STAFF REPORT

Board of Zoning Appeals
Meeting Date: April 16, 2025

Case #:	BZA-2025-045	Address:	292 Gravel Bar
Appellant:	Joseph Nejd, Owner	Zoning:	“R-C” Recreational Comm.
Agent:	John Feick, Architect Joey Vassallo Builders, LLC, Contractor		
Request:	Request for Area Variances from Section 5.1.7 to allow for the rebuild of a single-family home to encroach into the south, side-yard setback (1'8" proposed/ 5' required) and to Section 7.12.3.C to raze an existing nonconforming structure more than 75% of the existing floor area and rebuild in the same location.

SITE PLAN
1"=10'-0"

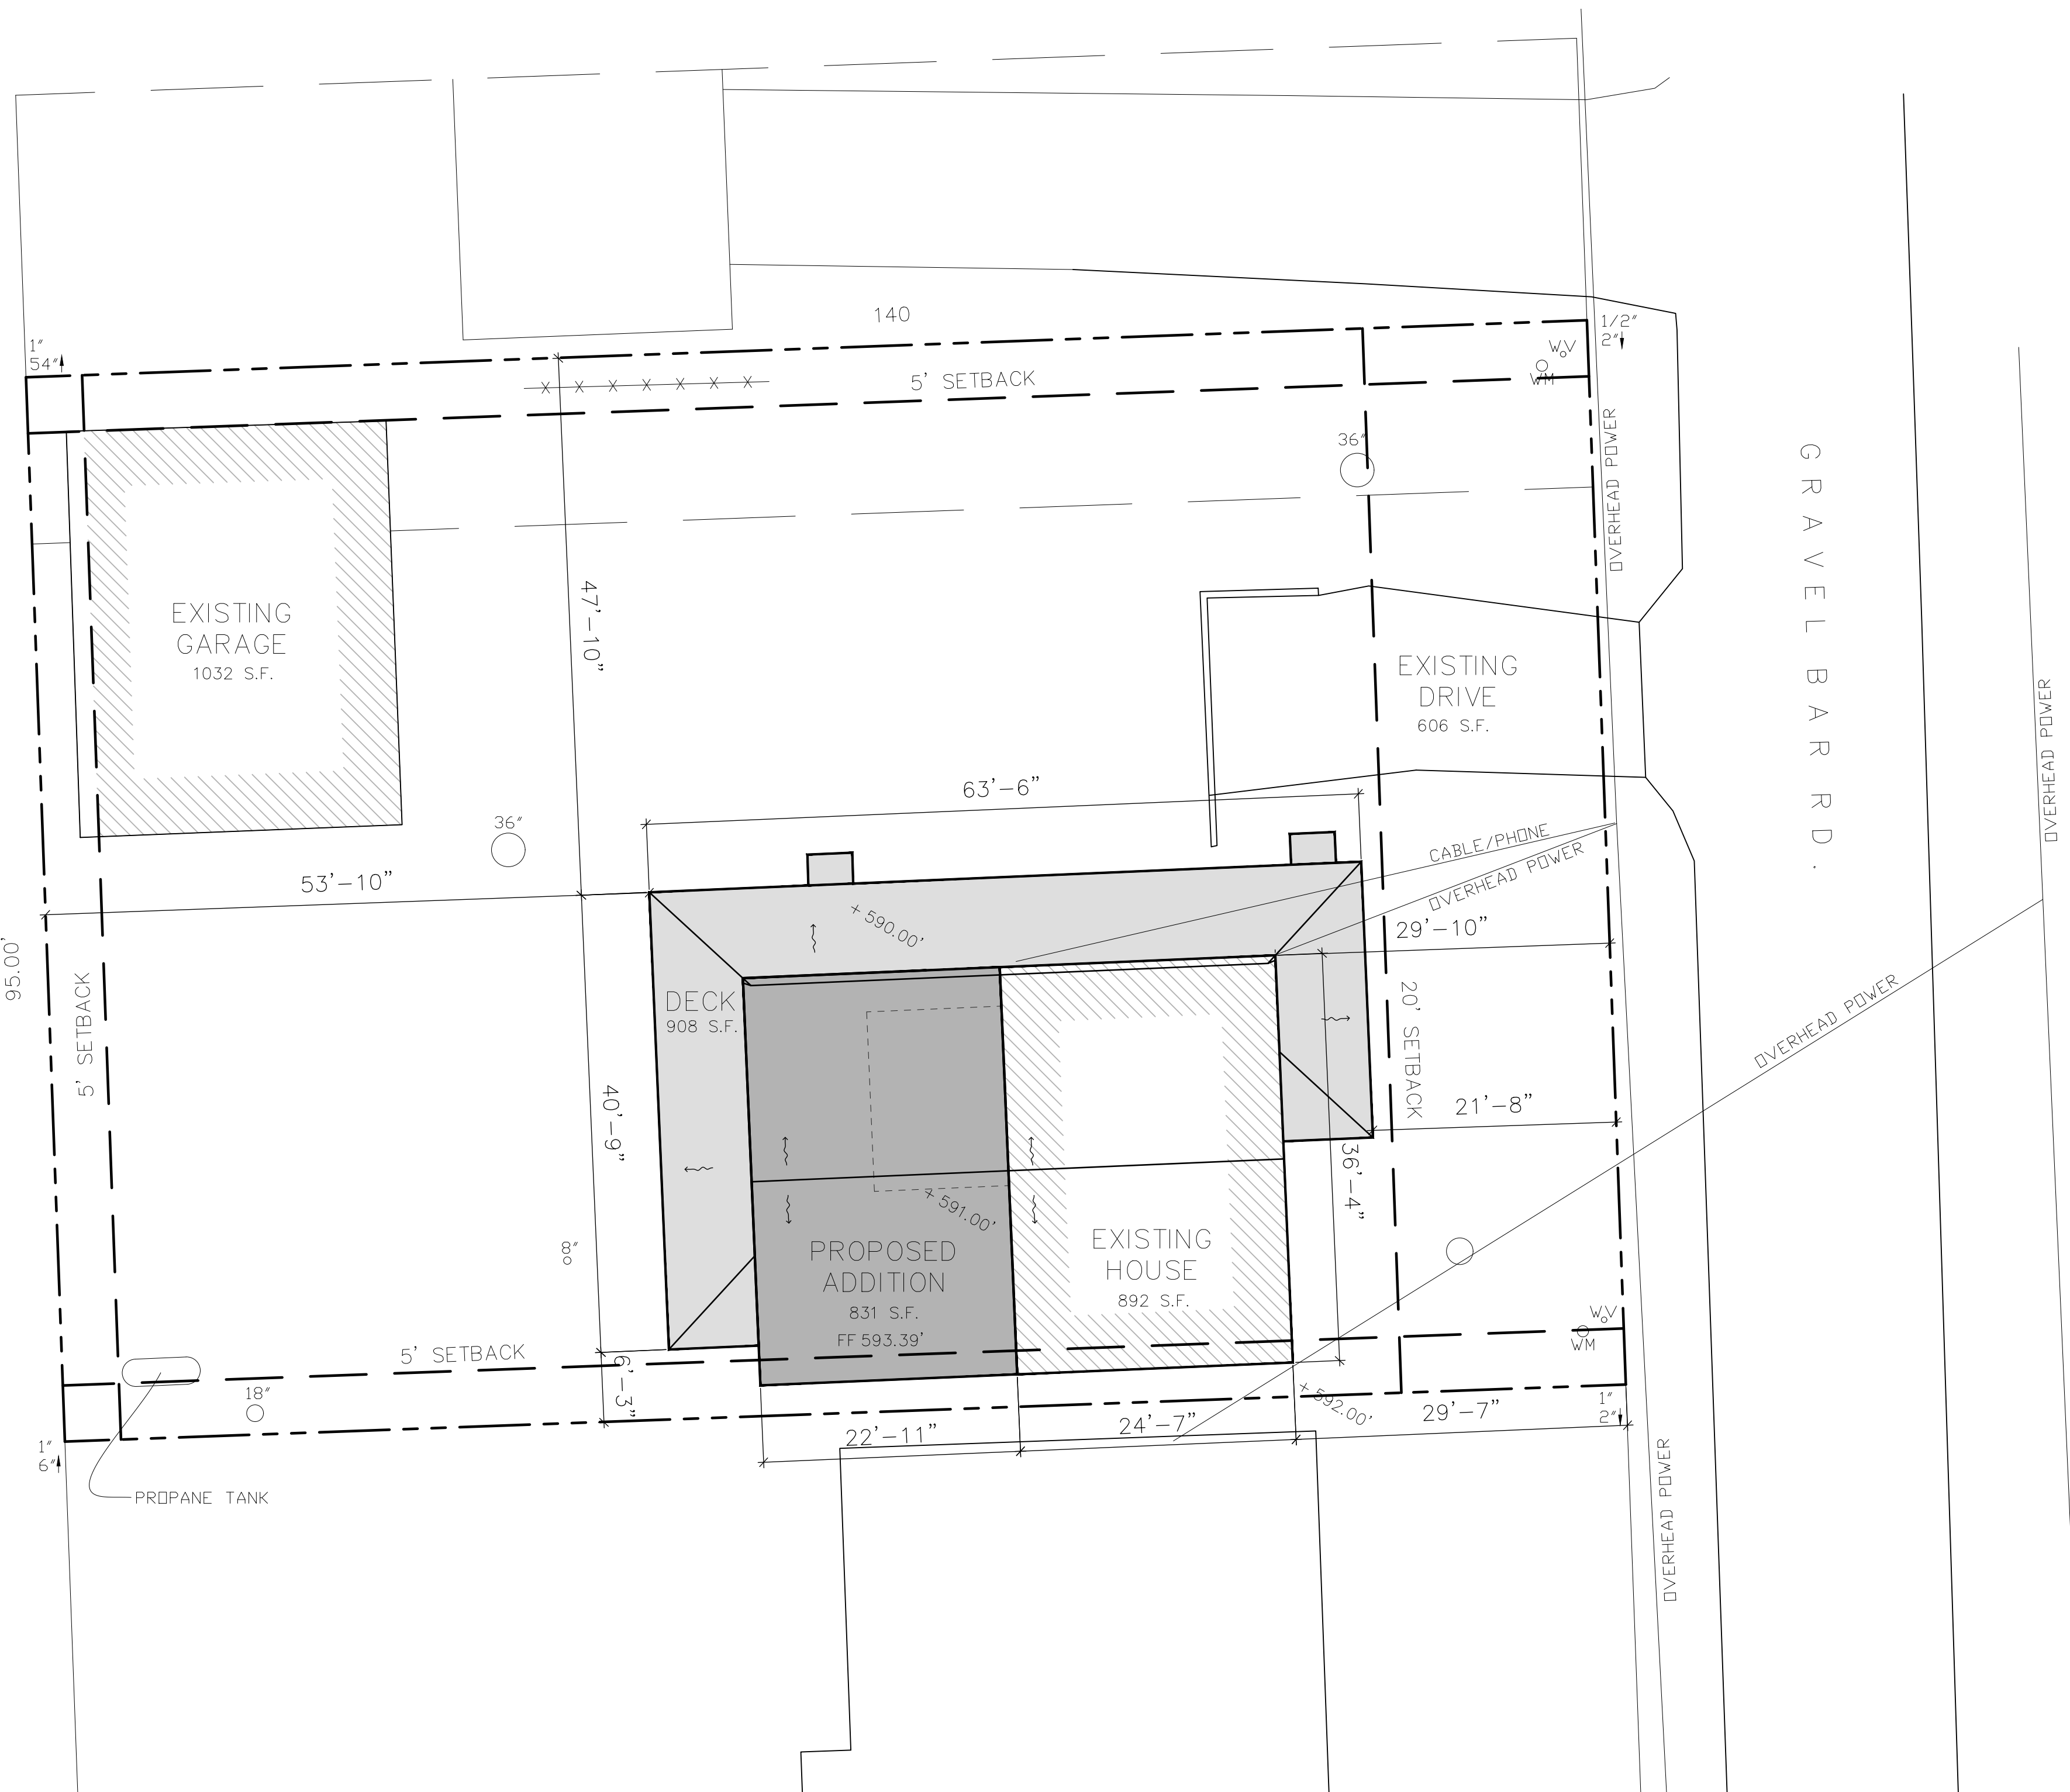
The applicant is proposing to rebuild the single-family home, including the 2024 proposed addition in the same location of the former structure which will be 2'8" to the south, side property line (1'8" if an overhang is present) where 5' is required. Essentially with the tear down of the original part of the house, the previous variances granted in 2024 are now null-in-void since we are no longer dealing with an existing, nonconforming structure, and this is now viewed as all new construction that should have been brought into compliance. The only change from the last application is that the applicant is now proposing a larger wrap-around porch in this application, which meets the setback requirements. The porch portion and "addition" is no longer subject to the 20% addition limitation since we no longer have a

- The property is part of the Port Ann Subdivision which was platted in 1951.
- The existing home is nonconforming because it is 2'8" from the south, side property line (1'8" if an overhang is present).
- The applicant is proposing to tear down and rebuild the single-family home in the same location as the existing home from the south, side property line at 2'8" where 5' is required.

SITE PLAN

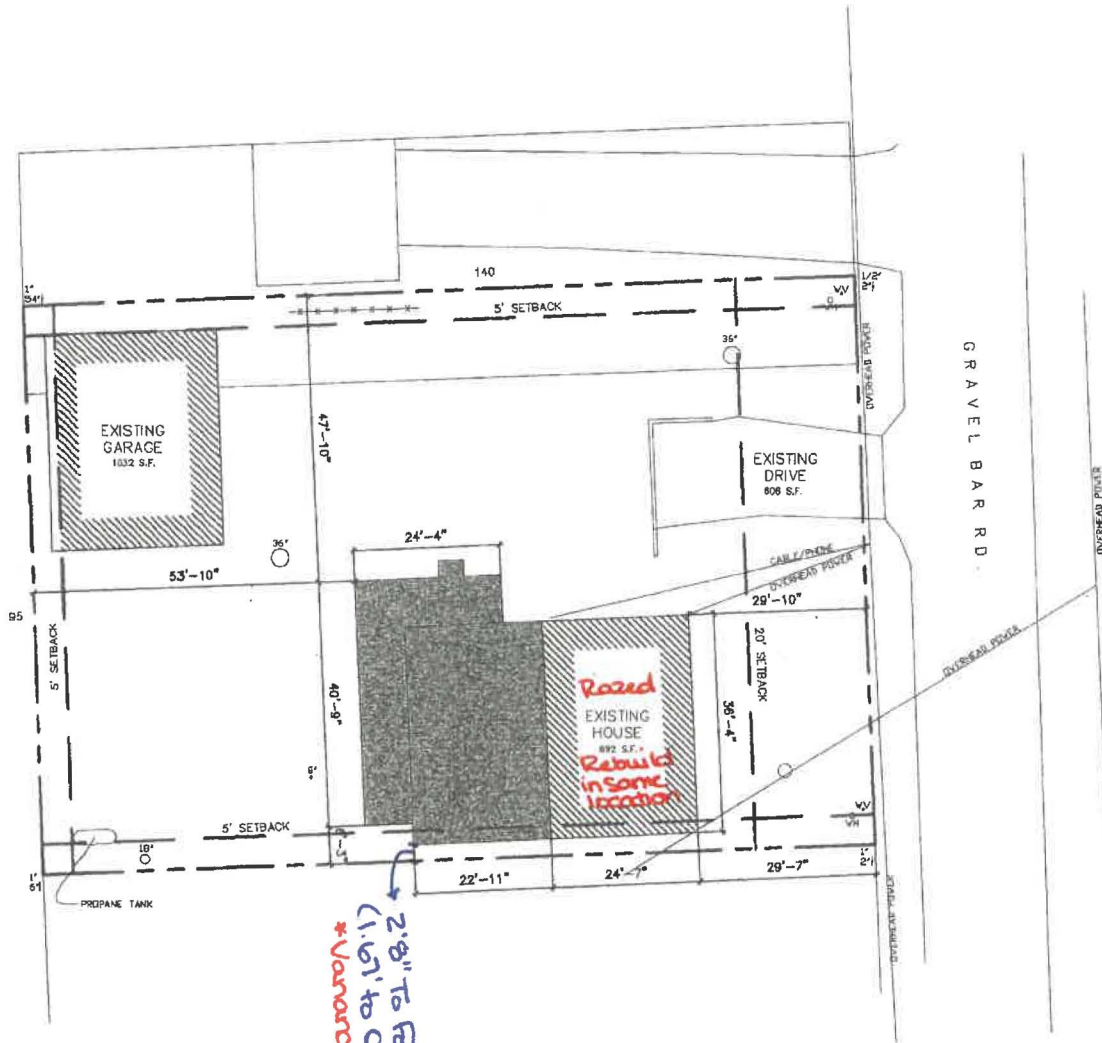
*2'-8" To Foundation
(1.6' to Overhang)
Variance Needed

** 2nd variance needed for Razing house & starting to rebuild in same location*
